Date:	15 February 2019	Distribution:
To:	General Contractors	
From:	Melissa Edwards, AIA	
Subject:	RFI's Recieved

Image 1

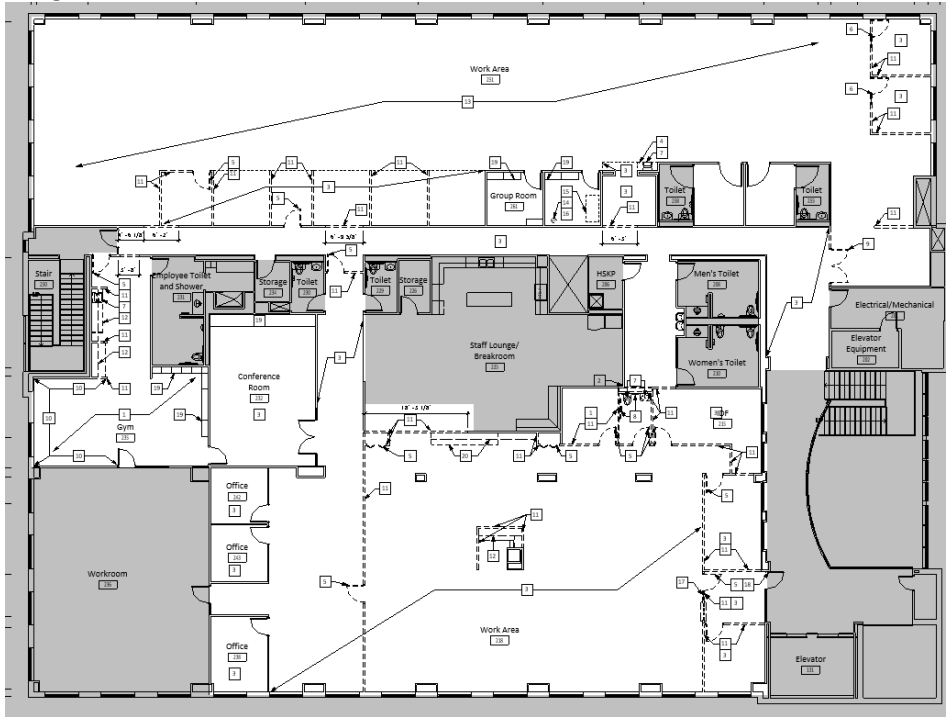
Response: Only CPT-1 will be used.
13. Is it safe to assume all grey area NIC/Existing to remain?
Response: Yes. Image #1 below shows the areas not in scope.

Image #2

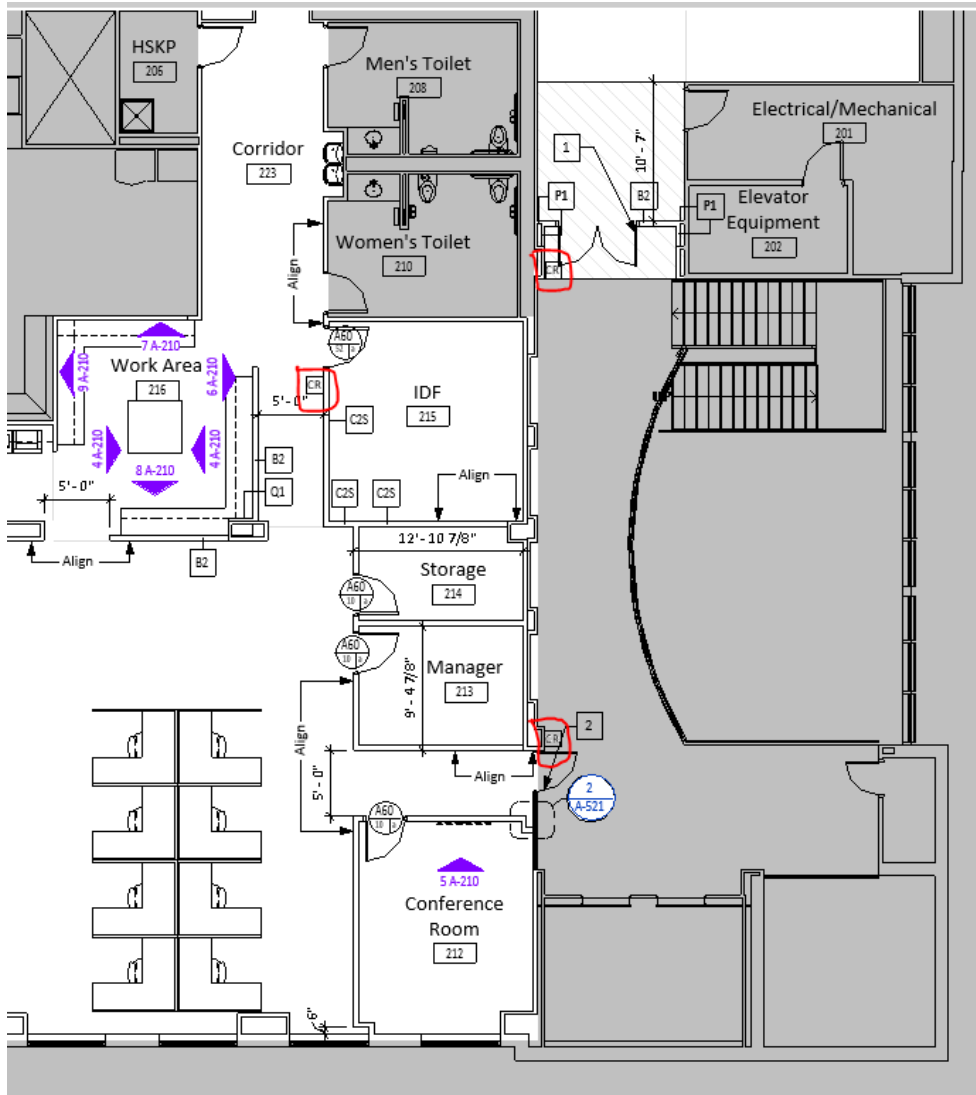
14. Do you know the finish of the hardware which needs to be supplied?
Response: US26D Satin Chrome, verify this is what's existing. See Image #2
